**REGULAR MEETING
OF THE VINEYARD PLANNING COMMISSION,
Wednesday, February 17, 2021 at 6:00 p.m.**

Date: February 17, 2021
 From: Morgan Brim, Community Development Director
 To: Planning Commission
 Item: Central Utah Water Conservancy District Well Site 17, Conditional Use Permit
 Address: 349 North Geneva Road, Vineyard, Utah
 Applicant: Shaun Hilton, Project Engineer, Central Utah Water Conservancy District (CUWCD)
 Owner: Anderson Geneva, LLC

Item: Eastlake Lot 05, Site Plan

SHEET LS1.2

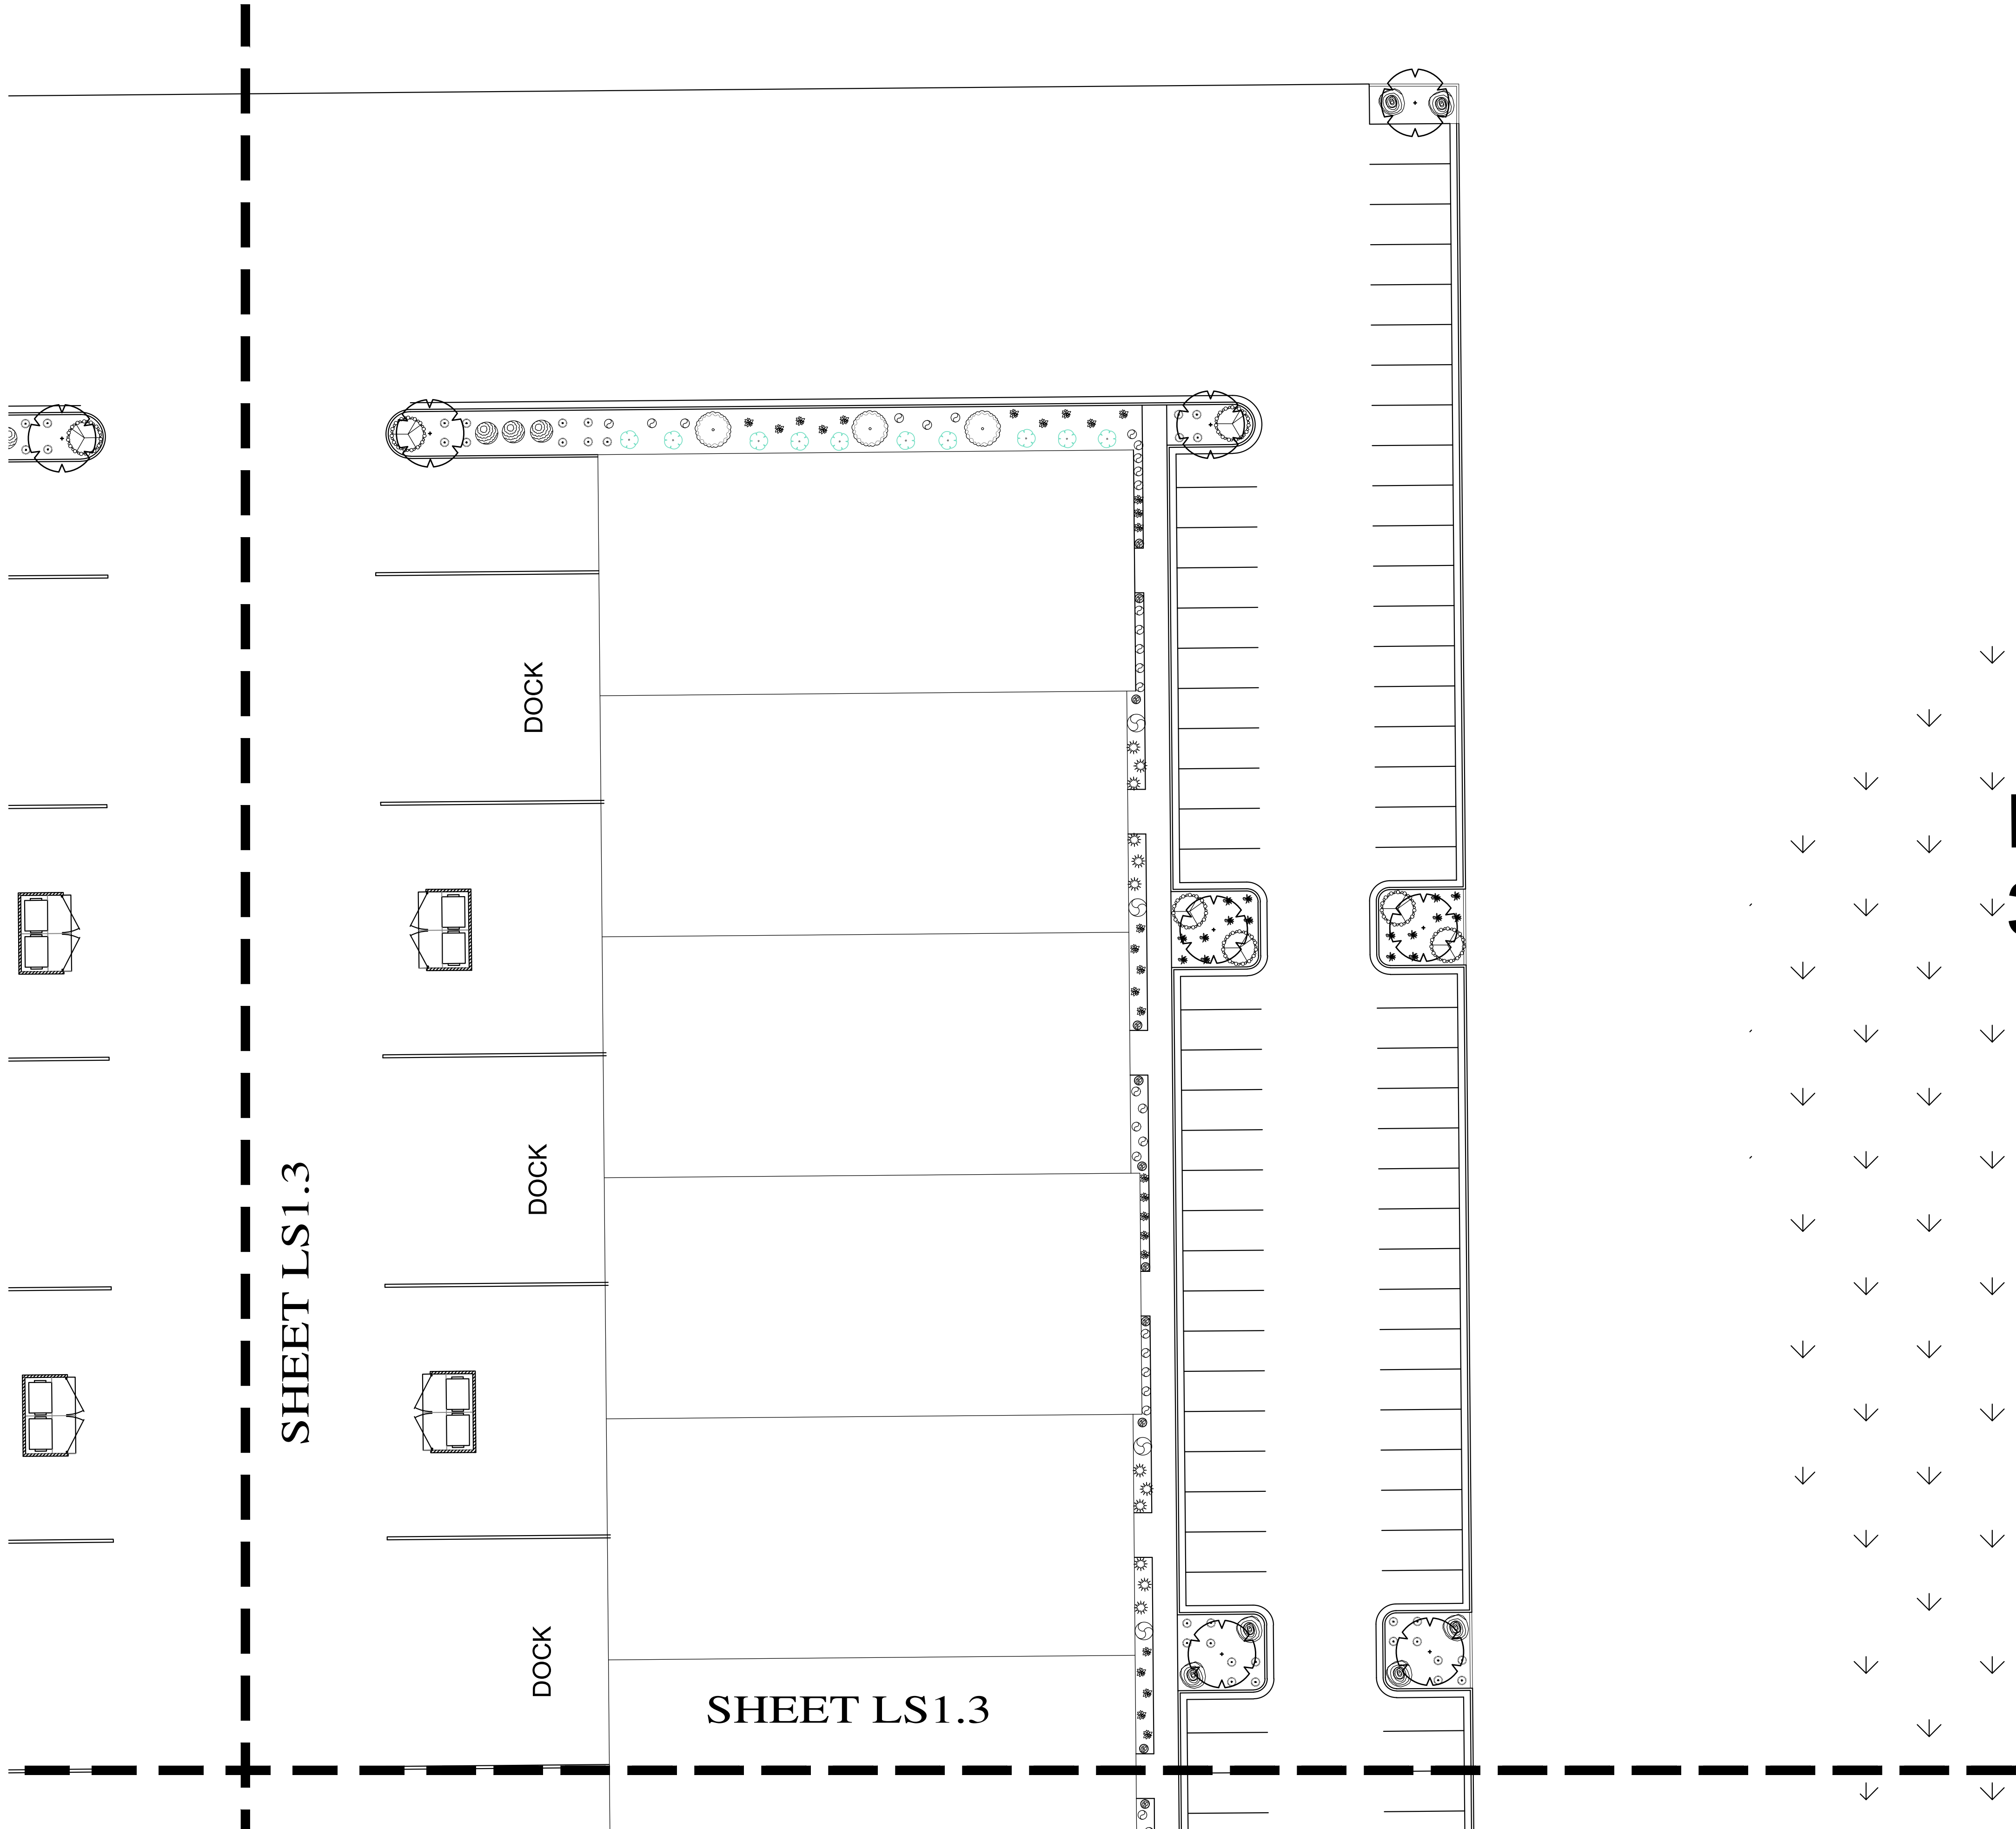
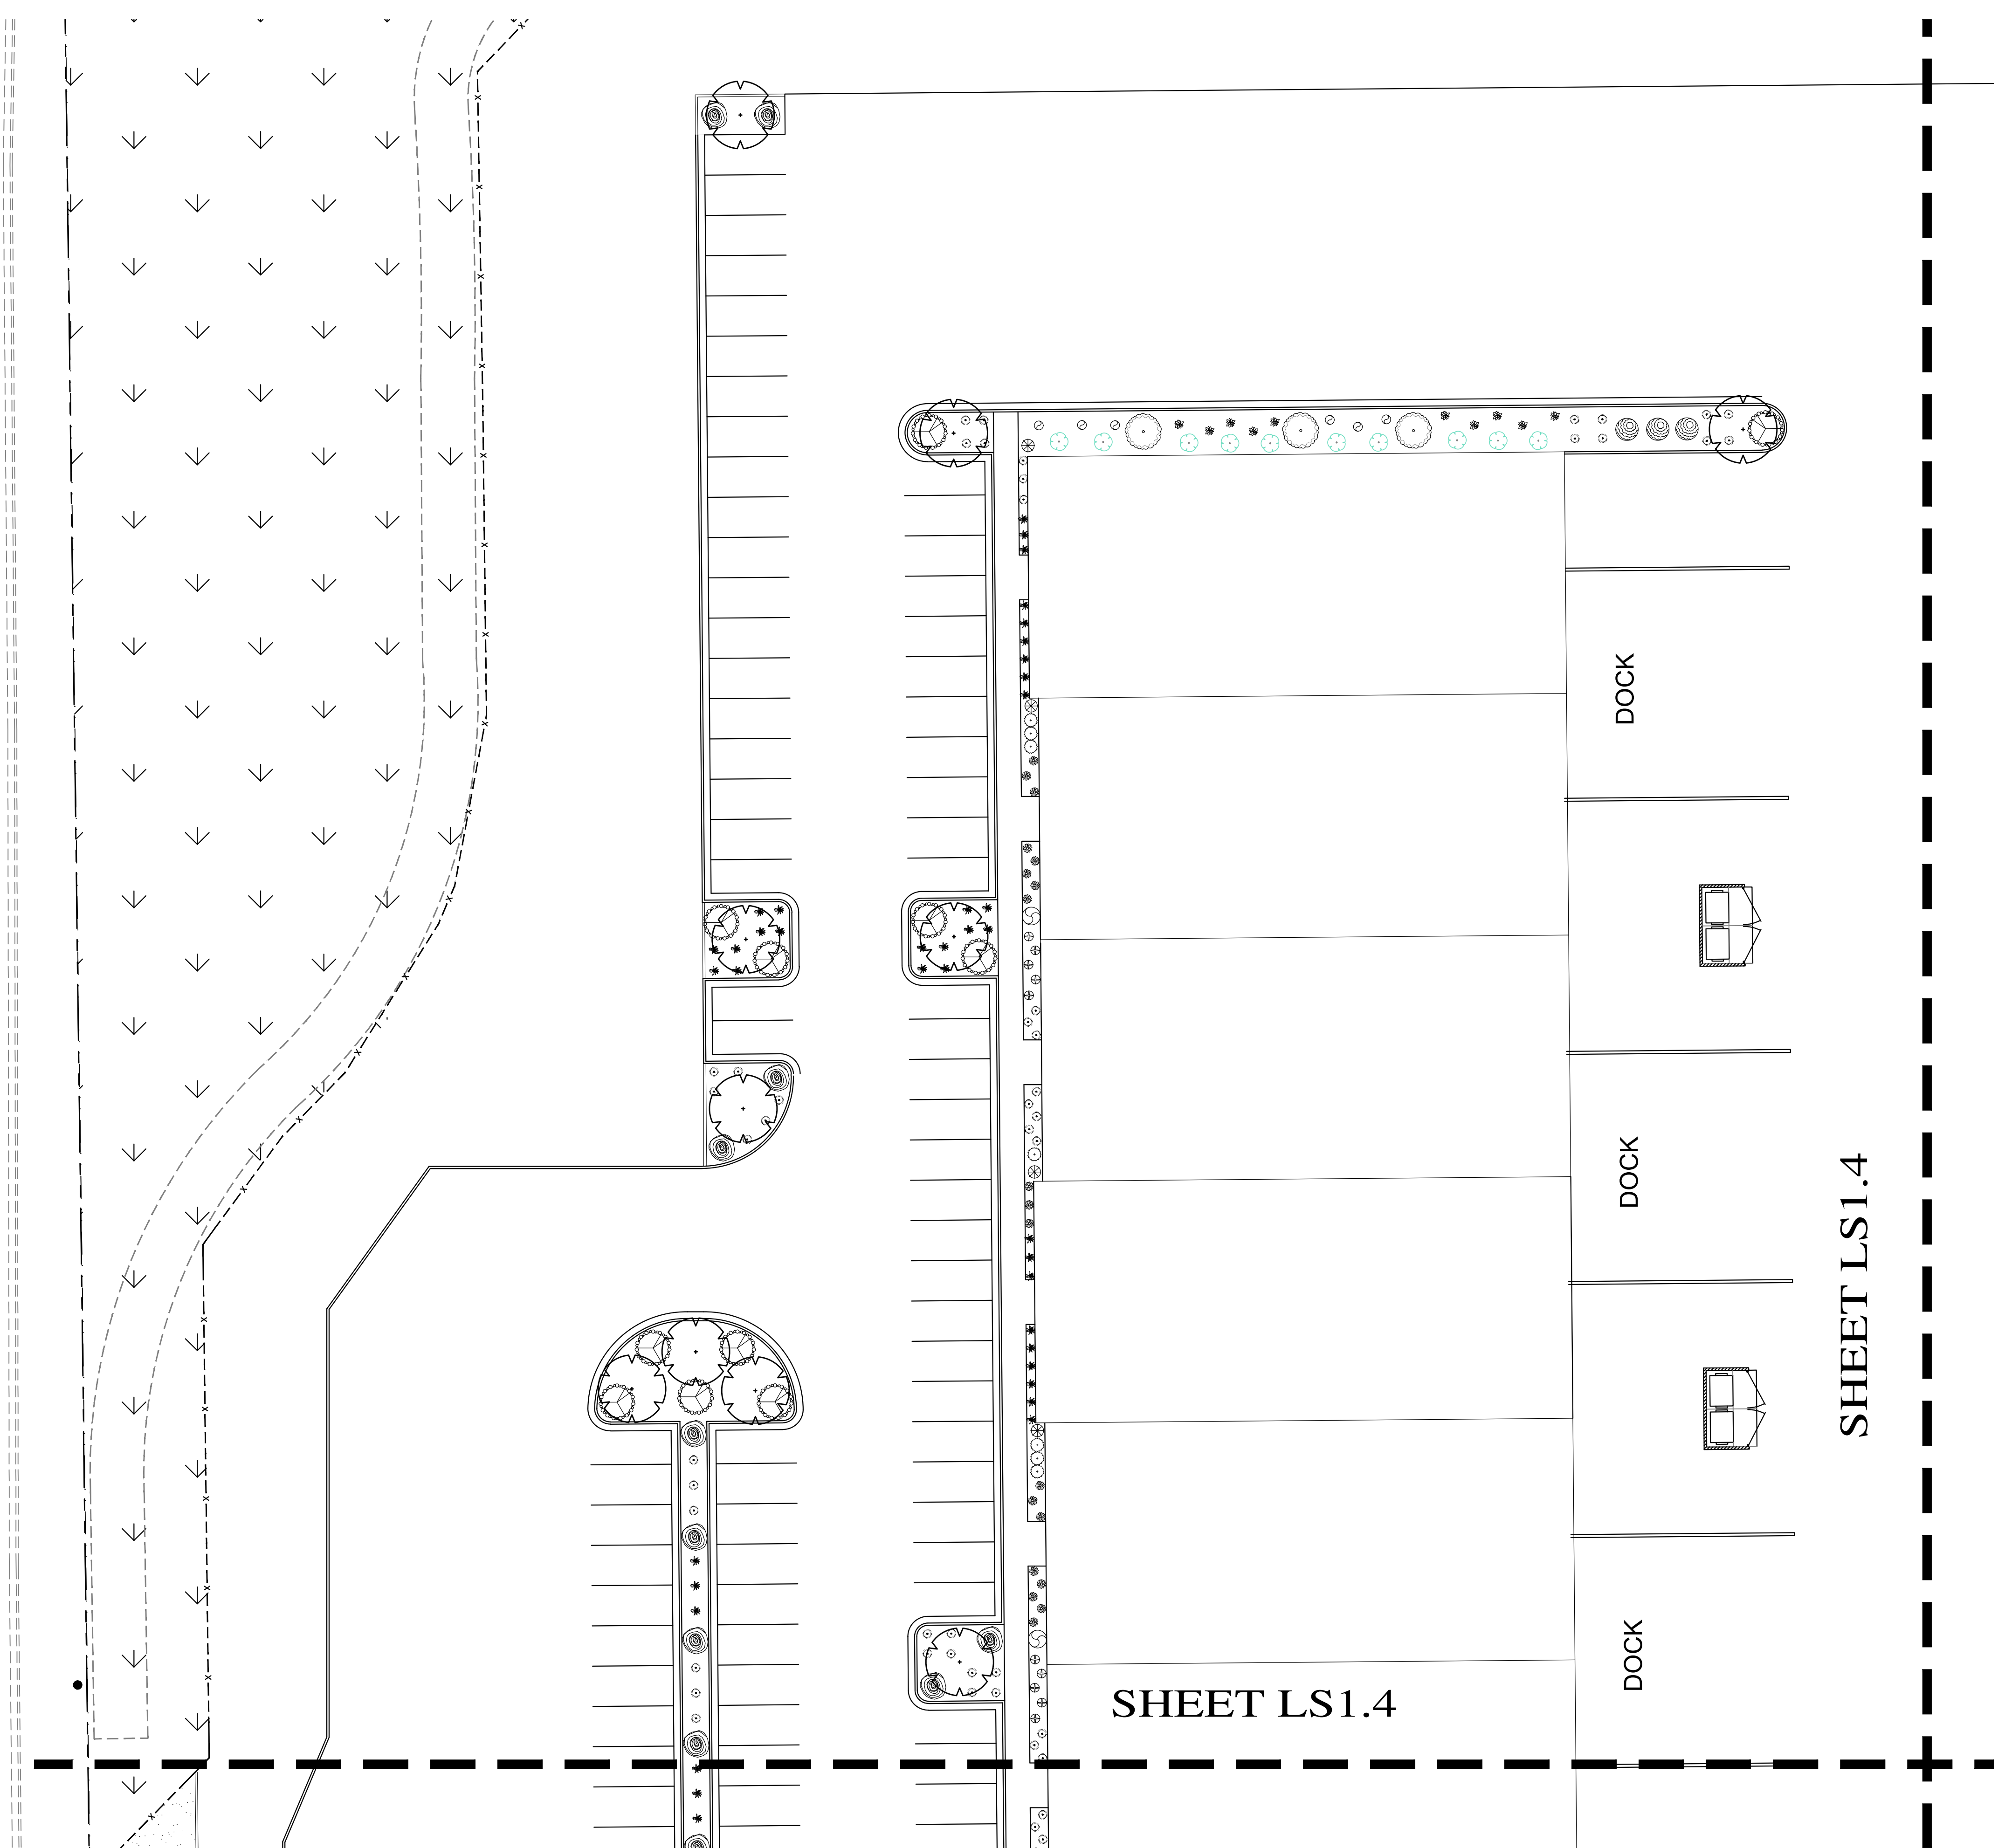
15.36.030.13.a Landscape Buffers	Landscape buffers between dissimilar or conflicting land uses shall be provided. Landscape buffers shall be provided for off-street parking and service areas and these areas shall be screened from public streets.	This site plan shall be approved only on the condition that the applicant provided screening of all parking areas from the public right-of-way.	☒ Yes ☐ No ☐ N/A

15.36.030.13.c Landscape Materials	All proposed plantings and site materials should be consistent with (but not uniform) and of a similar scale with existing natural neighboring landscape, and adjacent streetscape areas where appropriate. Drought tolerant "xeriscape" landscaping is encouraged. Landscaping improvements may also include berming, contouring, rocks, and boulders.	The natural habitat has been left preserved near the perimeters of the property. Inside the property lines—between the property lines and the structures, gravel or other porous material will infill spaces. Near parking egress paths and high-density pedestrian areas, a native sod material will be placed, as well as trees and other coverings. Xeriscape shall be installed throughout the site. Proposed landscaping is consistent with existing landscaping at other properties along 1750 N. A large percentage of the plants specified are drought tolerant species with rock mulch used as a top dressing of planter beds. Use of drip irrigation of	☒ Yes ☐ No ☐ N/A

constructed of materials that are compatible with the residence.		
15.36.030.15 Non-vegetative Ground Cover	Non-vegetative ground cover treatments may include rocks and small stones, granite, and bark. Areas of non-vegetative ground cover materials shall be broken and interspersed with plant materials.	A porous gravel will be placed in regularly unoccupied areas. Use of crushed rock mulch over weed barrier fabric has been called out on the plans.	☒ Yes ☐ No ☐ N/A

15.40.080.1.d. Plant Materials	Plants shall be drought tolerant and well-suited to the soil conditions at the	The applicant shall provide all water	☐ Yes ☐ No

project site. Plants with similar water needs shall be grouped together in landscape zones as much as possible. The applicant shall provide water requirements for all plant material. Plant materials shall be chosen from the approved Vineyard Tree Manual.	requirements for all plant material.	☒ N/A
